## PLAT COMMITTEE

July 12, 2023

**Case Number:** 2023-PLT-043  
**Property Address:** 7511 New Augusta Road (Approximate Address)  
**Location:** Pike Township, Council District #1  
**Petitioner:** Doug Wagner – New Augusta SF, LLC  
**Zoning:** D-4  
**Request:** Approval of a Subdivision Plat to be known as Ashton, Section 1B, dividing 14.63 acres into 47 lots.  
**Waiver Requested:** None  
**Current Land Use:** Ball Fields  
**Staff Reviewer:** Linda Ahlbrand, Principal Planner II

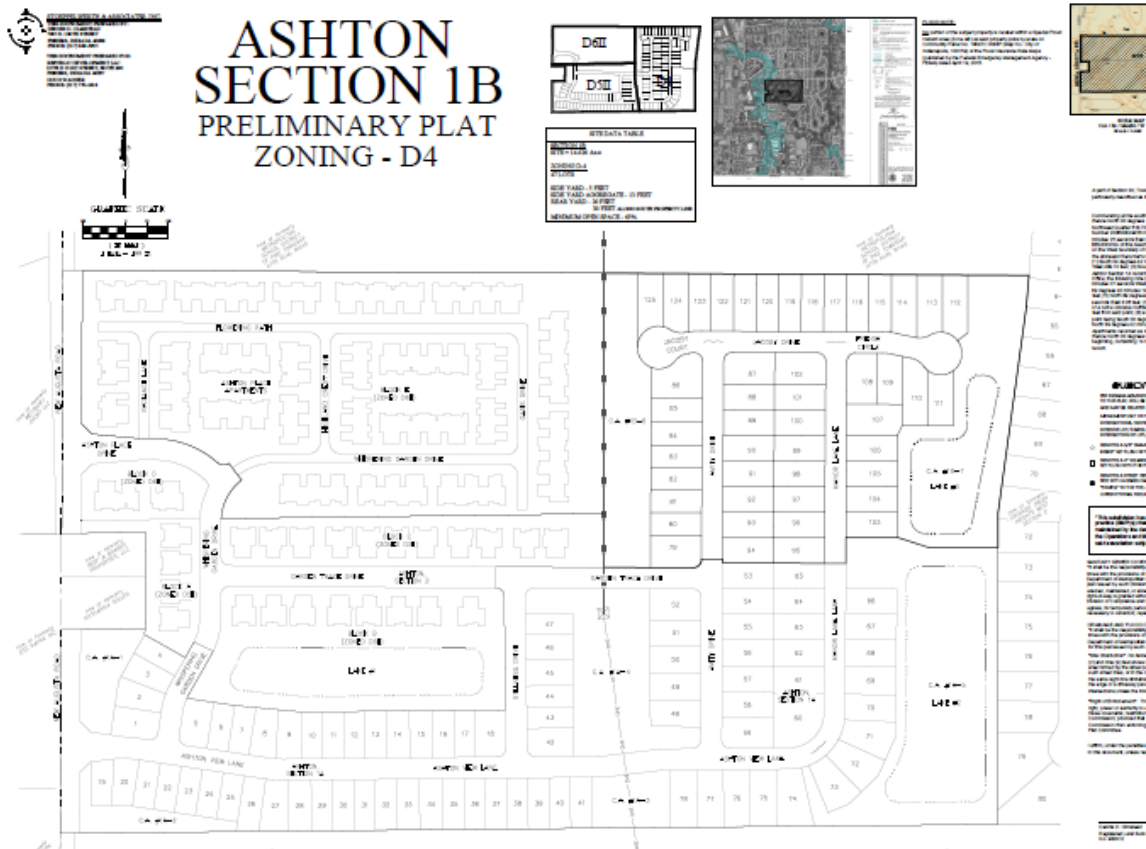
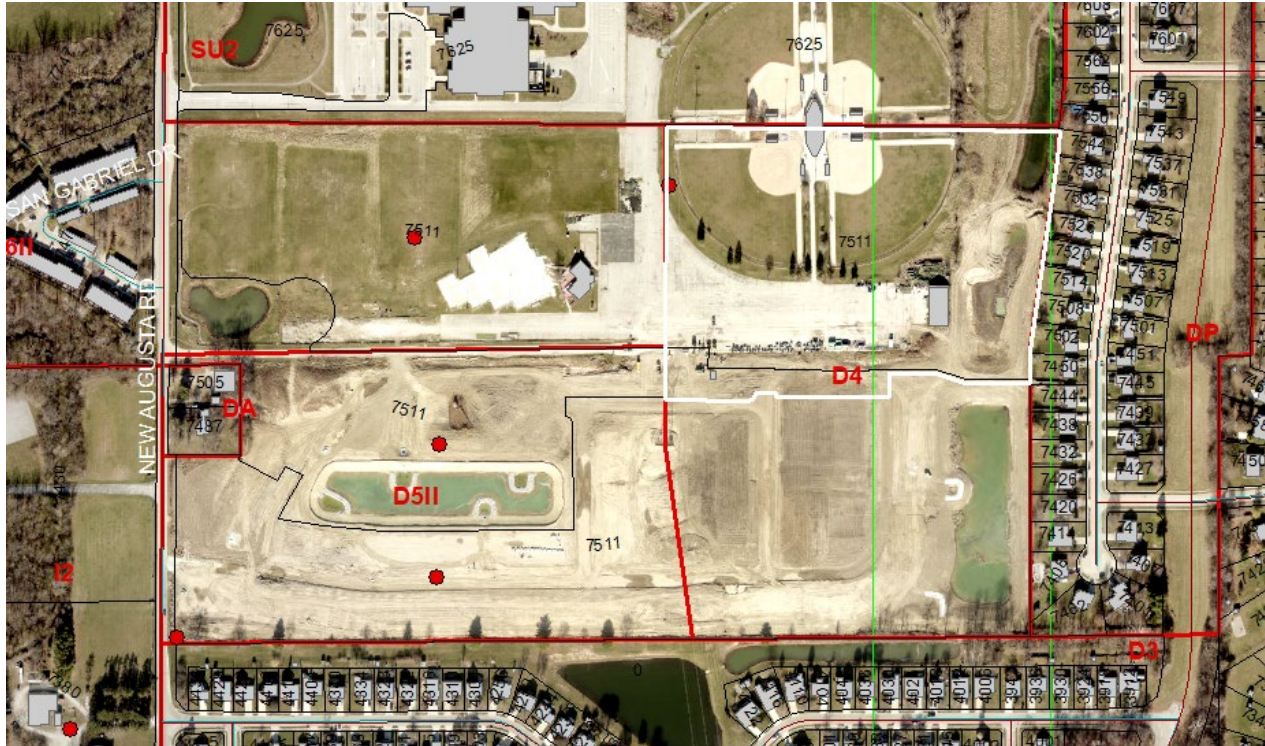
9. That the Storm Drainage Covenant (Section 741-703, of the Consolidated Zoning and Subdivision Ordinance) be affixed to the final plat prior to recording.
10. That the plat restrictions and covenants, done in accordance with the rezoning commitments, be submitted prior to recording the final plat.
11. That all the standards related to secondary plat approval listed in Sections 741-207 and 741-208 of the Consolidated Zoning and Subdivision Ordinance be met prior to recording the final plat.
12. That all lots shown with a 53-foot lot width be increased to meet the minimum lot width of 54 feet.

The minimum lot width in the D-4 district is 60 feet. The Ordinance allows for a 10% reduction of the lot width for 20% of the lots. A 10% reduction would result in a 54-foot lot width. Some of the lots in Section 1B are shown with a lot width of 53 feet. Therefore, these lots need to be increased to 54 feet prior to final plat recording.
